Responses to Information Requirements and Clarifications – Round 2

**For
Flemish Pass Exploration Drilling Program
(CEAR 80129)**

**Eastern Newfoundland Offshore Exploration Drilling Project
(CEAR 80132)**

Equinor Canada Ltd.

Figure 1 Special Areas Intersecting with Project Area ELs and Zones of Influence

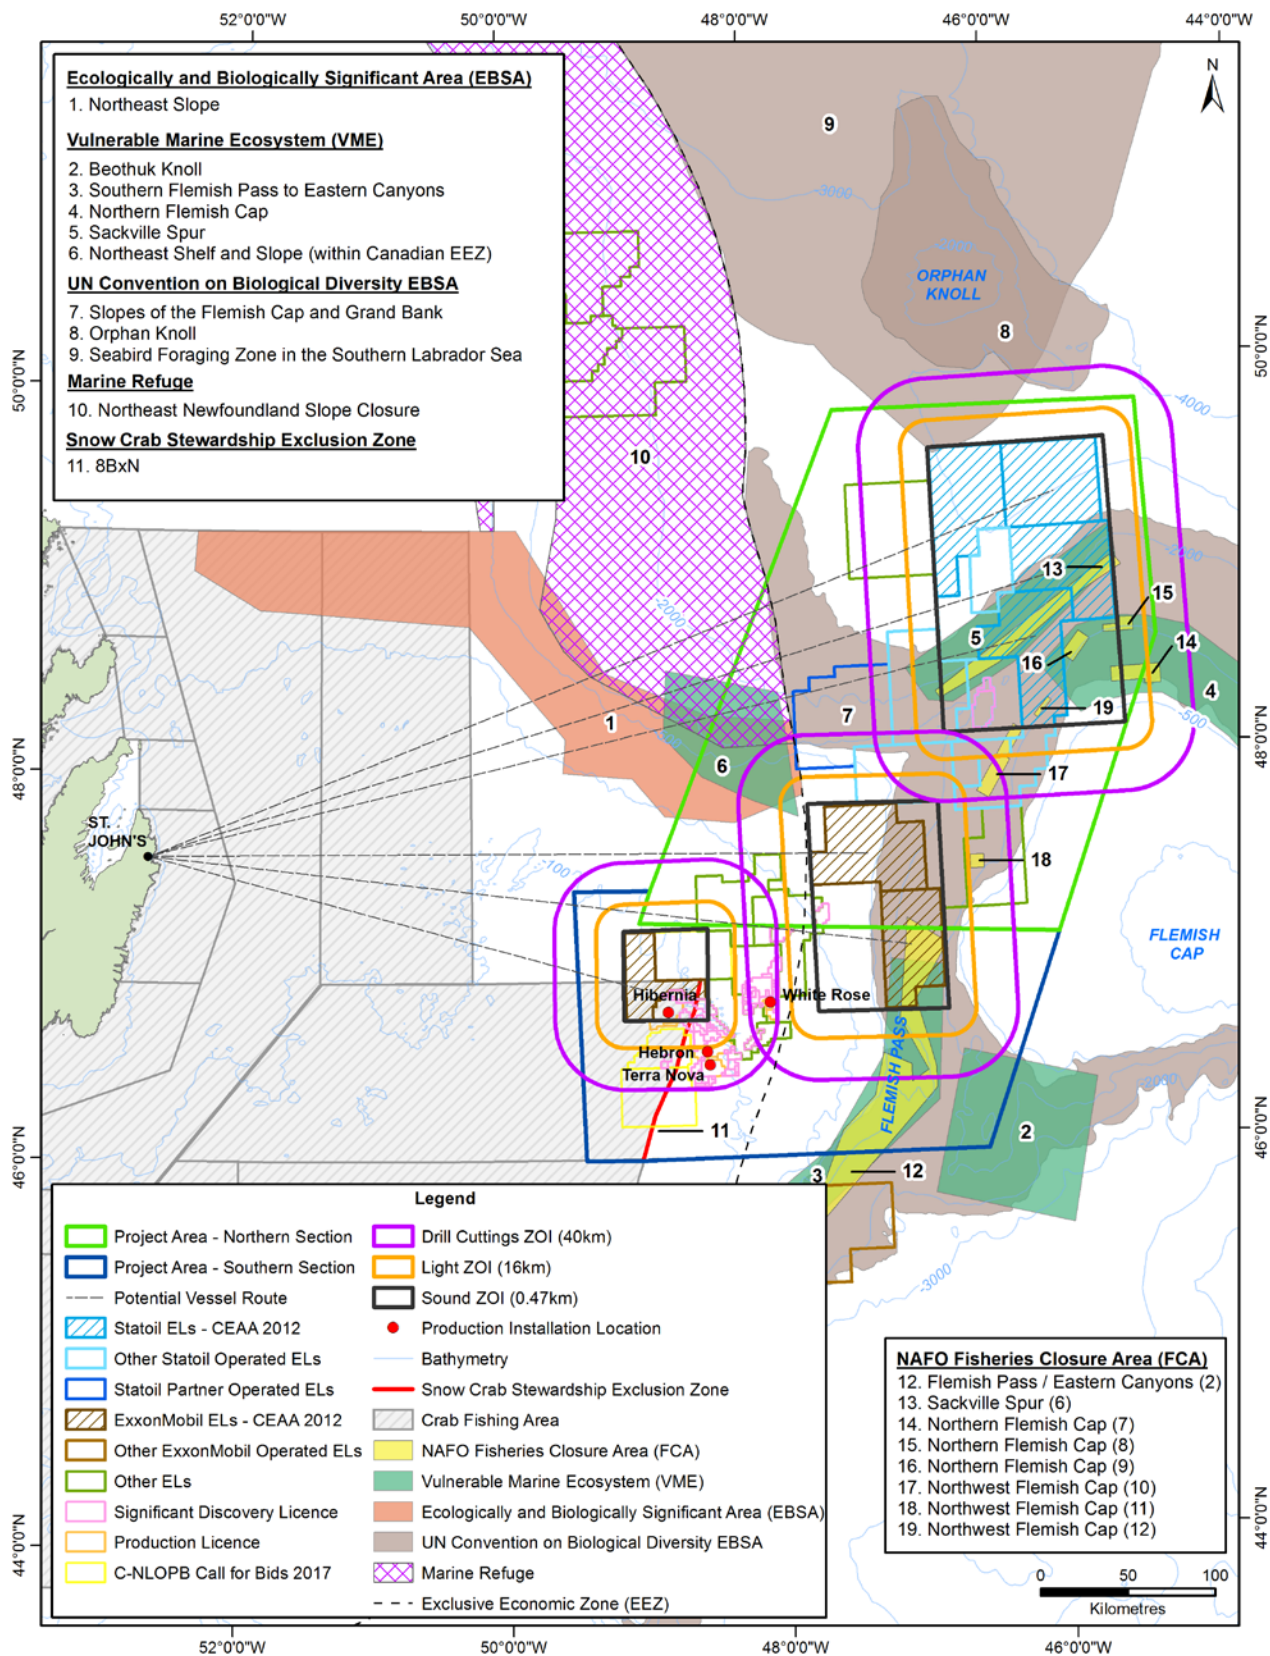
Consolidate the information from the EIS, IR-39 and also the EIS Addendum for the addition of exploration licence 1134 to provide one table and one figure depicting distances to special areas that could be affected by the Projects.

The figure, similar to Figure 11-2 in the EIS, should depict all the special areas that overlap with the project area as well as with the potential vessel and aircraft routes. The figure should also include any special areas that, while not directly overlapping with the project area or vessel and aircraft routes, may be within the zone of influence for effects of routine Project activities.

Table 1 and Figure 1 below consolidates information from the Environmental Impact Statement (EIS), Table 6 from the original response to this Information Requirement (IR) and Table 4.17 from EIS Addendum associated with the ExxonMobil Canada Ltd. (ExxonMobil) exploration license (EL) 1134. Figures 1 and 2 also outline the zones of influence (ZOI) associated with drill cuttings, light and noise, which is also applicable for the response to IR-40-2. For details associated with ZOI refer to the response to IR-40.

Figure 2 Figure 4-29 of ExxonMobil's Appendix E

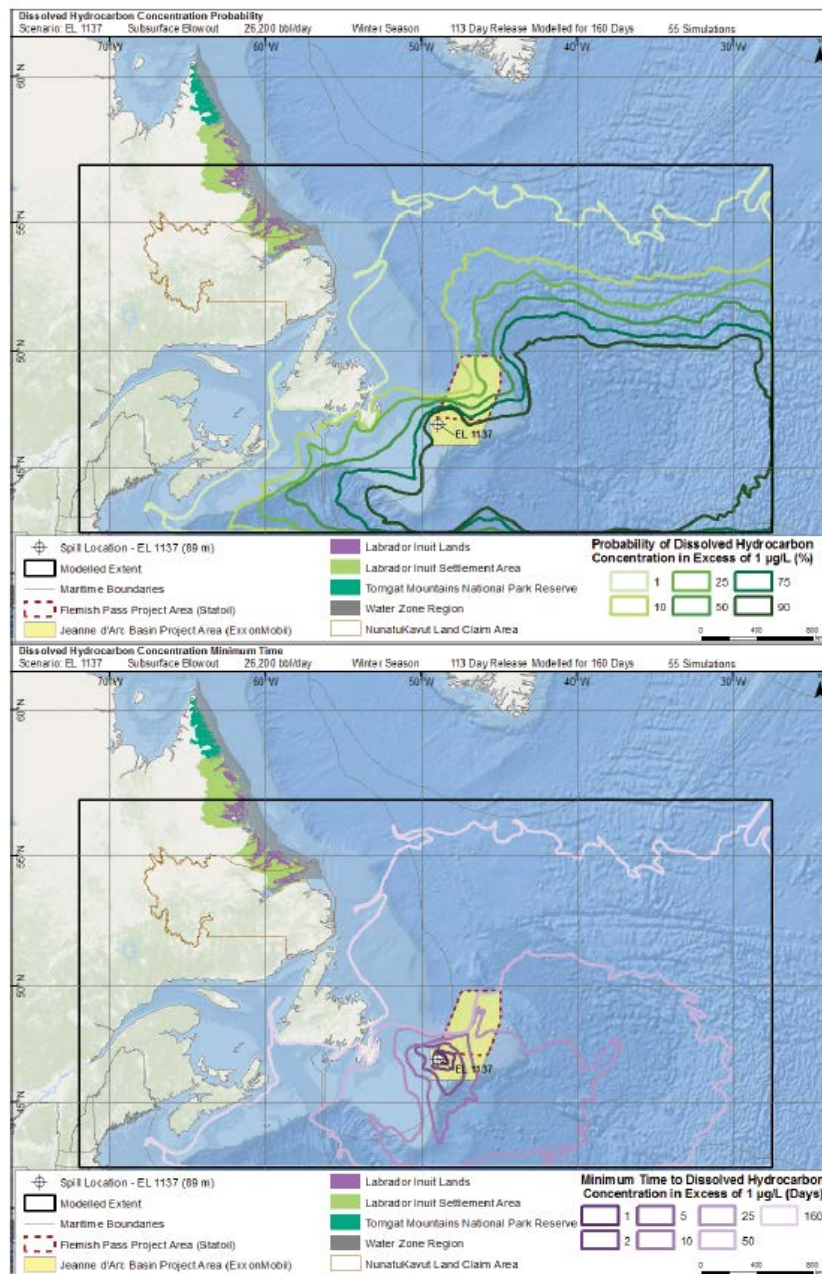
The proponents' response also states that oil exposure greater than 1 gram per meter squared is not anticipated to reach the Gulf of St. Lawrence, however figures 4-10, 4-11, 4-12, 4-29 and 4-30 of Eastern Newfoundland Appendix E and figures 15-7, 15-8 and 15-20 of the Eastern Newfoundland EIS appear to show probability of oil exceeding thresholds within the Gulf of St. Lawrence.

Provide project-specific discussions of the probability that oil from a vessel spill or well blowout could reach the Gulf of St. Lawrence and describe the potential environmental effects, taking into consideration existing modelling results which appear to show oil within the Gulf of St. Lawrence.

Fisheries and Oceans Canada (DFO) defines the Gulf of St. Lawrence in the *Gulf of St. Lawrence Integrated Management Plan* (DFO 2013), which is also included as Figure 1 below. Based on the boundaries of the Gulf of St. Lawrence outlined in Figure 1, the Operators concluded that applicable figures in Appendix E (i.e., 4-10, 4-11, 4-12, and 4-30) and the EIS (i.e., 15-7 and 15-8) do not show oiling within the Gulf of St. Lawrence. However, the Operators recognize that Figure 4-29 in Appendix

E does result in a low (i.e. less than 1%) probability of shoreline oiling and is associated with a minimum time of 100 days (Figure 2). As mentioned in Section 4.1.3 of Appendix E, it is important to note that the stochastic figures do not imply that the entire contoured area would be covered with oil in the event of a single release, and oil that is predicted to make contact with shorelines is expected to be highly weathered. These spill scenarios are considered representative of credible worst-case with no mitigation measures.
